Product Support Bulletin 2009-033

SUBJECT: LVDT Cable Recall – 22311168

MACHINE MODEL(S): TRIPP Tie Exchanger

SERIAL NUMBER(S): 760125-760358

Figure 1
TRIPP Rail Lifter Assembly

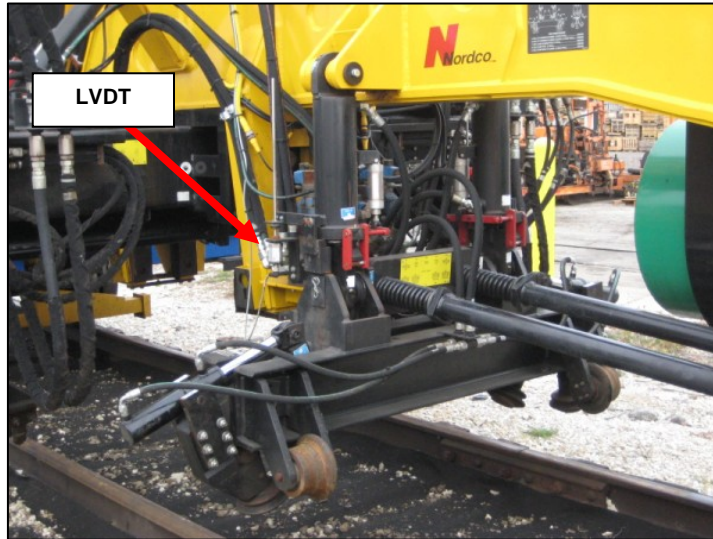
SUMMARY: The 22311168 LVDT Cable provides power to the Rail Lift LVDTs on the TRIPP machine. See Figure 1 on Page 2. On some of the cables, manufactured during December, 2008 and January, 2009, the positive and negative power leads were reversed.

OPERATIONAL IMPACT: If a cable with reversed power leads is installed on a machine, the LVDT will be destroyed and the Rail Lifter will not stop at the desired height but will try to lift all the way up to the limit of the cylinders. This can also occur if the LVDT cable is damaged or disconnected.

Figure 2
Rail Lifter LVDT and Connector

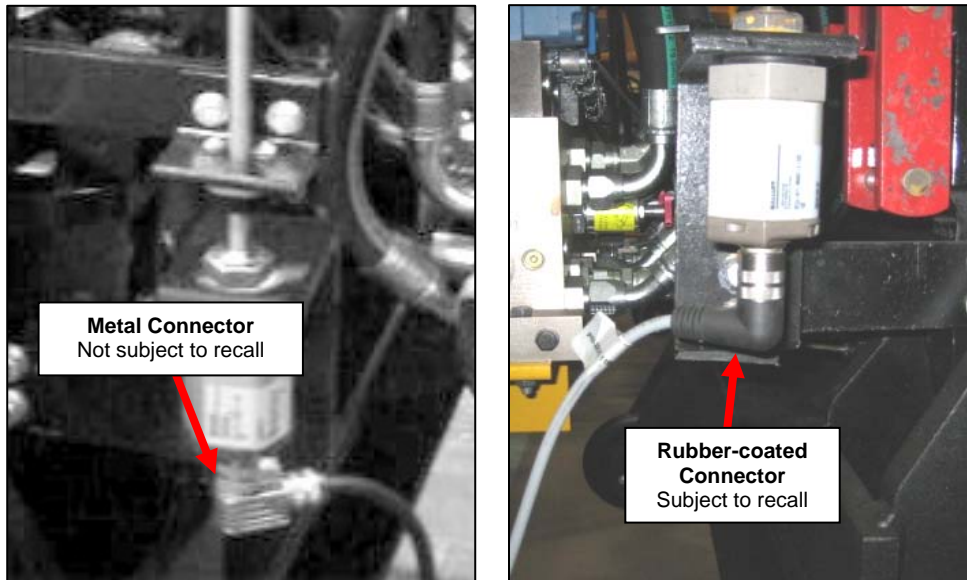
ACTION: There are 2 different LVDT connectors used on these cables, a metal connector and a sealed, rubber-coated connector. See Figure 2 on Page 2. The rubber-coated cables have a silver part number tag on the cable near the connector. The reverse side of this tag may have a date code printed on it as shown in Figure 3 on Page 3. The date code is a 4-digit number followed by the letters "US". **If the reverse side of the tag does not have a date code, the cable is suspect and should be returned to Nordco for replacement.** Cables with rubber-coated connectors with a date code or cables with metal connectors are not subject to this recall and will not be replaced. If a cable is already installed on a

Only cables with the Rubber-coated Connector shown on the right are subject to this recall

Figure 3

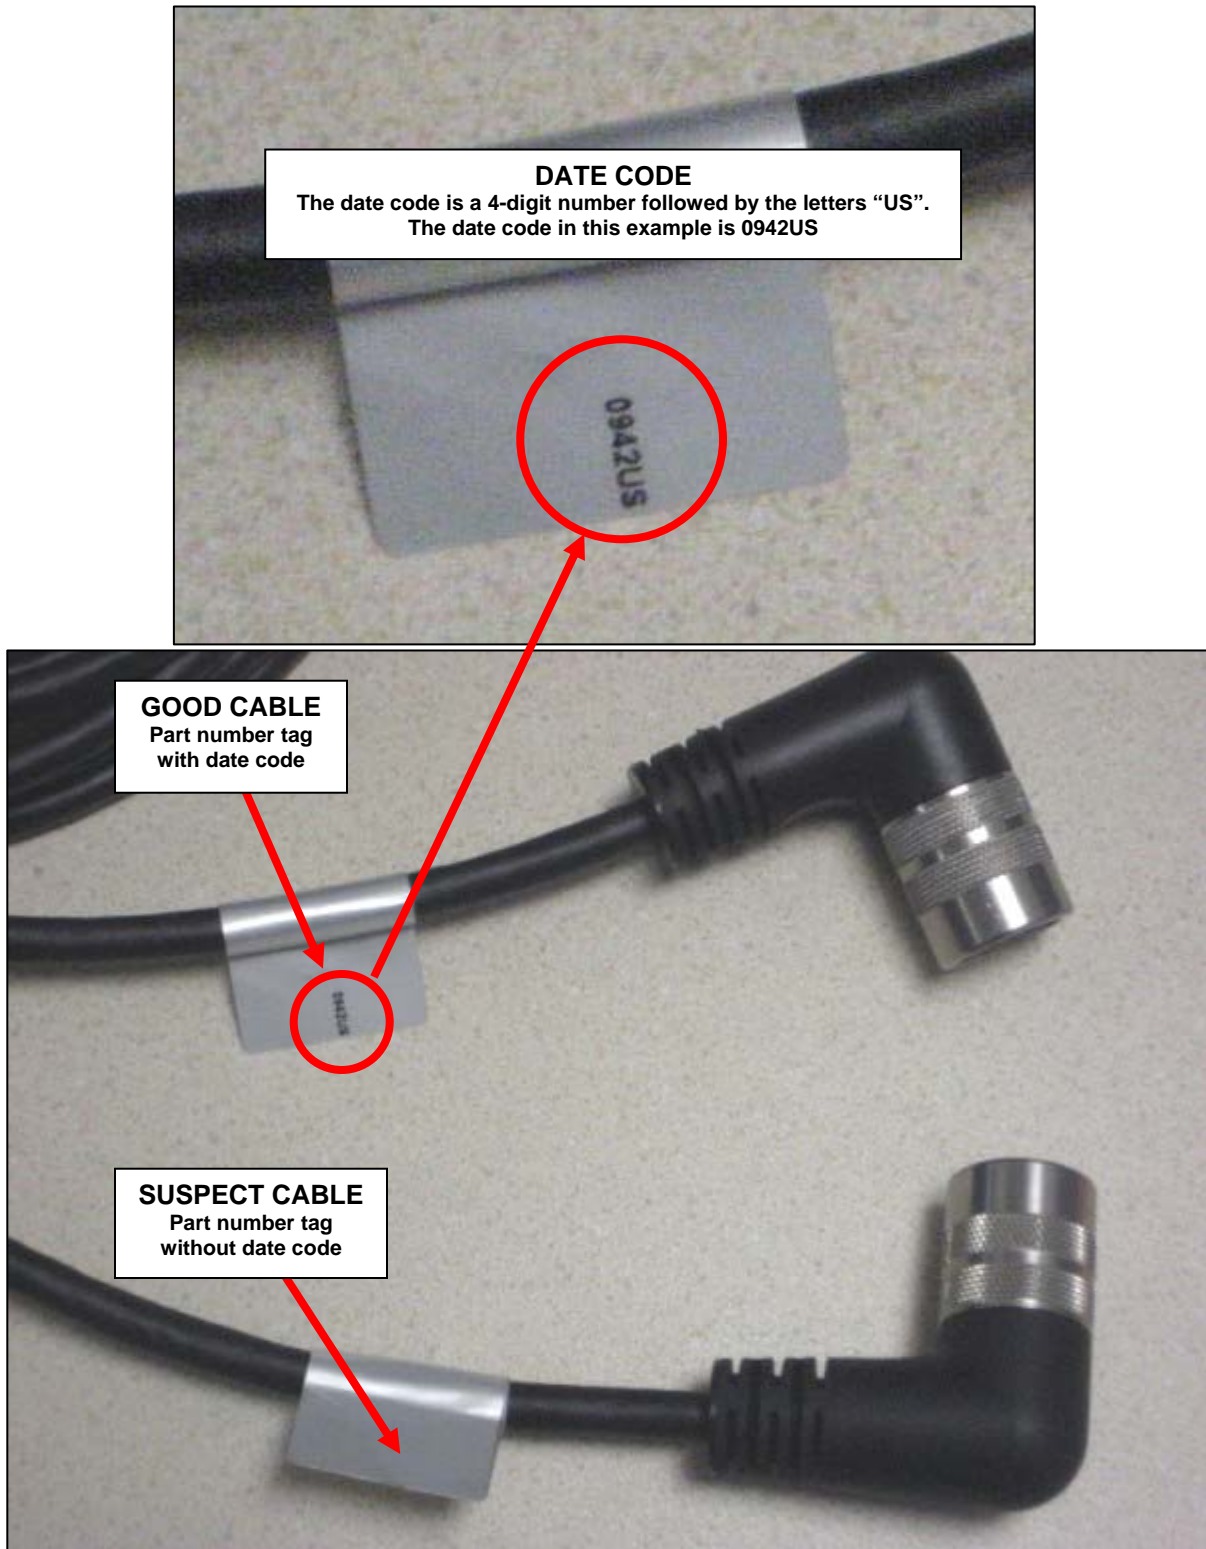
Good cables will have a date code printed on the part number tag as shown on the top cable.
Suspect cables will not have a date code as shown on the bottom cable.

machine, and the machine is working properly, the cable is not defective and does not have to be replaced. All replacement cables ordered from Nordco will have a date code printed on the tag.
